Service Information:

Oil seal quality improvement

Replacement p.n. 12015933B with p.n. 20029714B

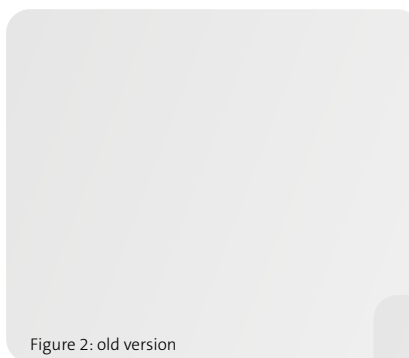
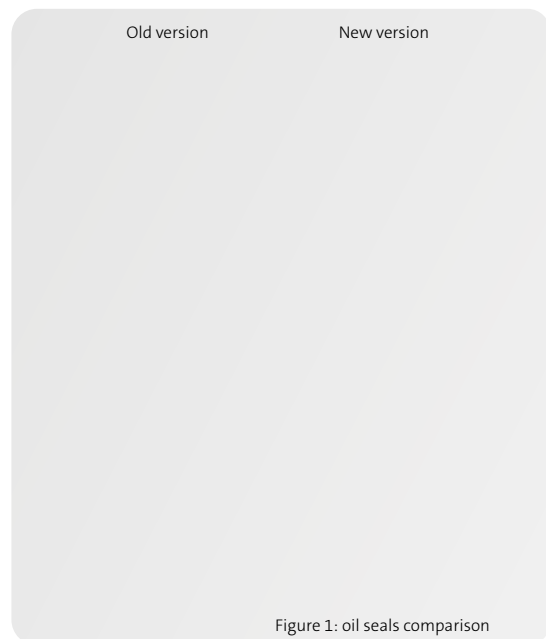
The oil seal 12015933B was replaced by the p.n. 20029714B.

The new outer diameter surface is completely covered by rubber in order to ensure better performance in the static sealing area.
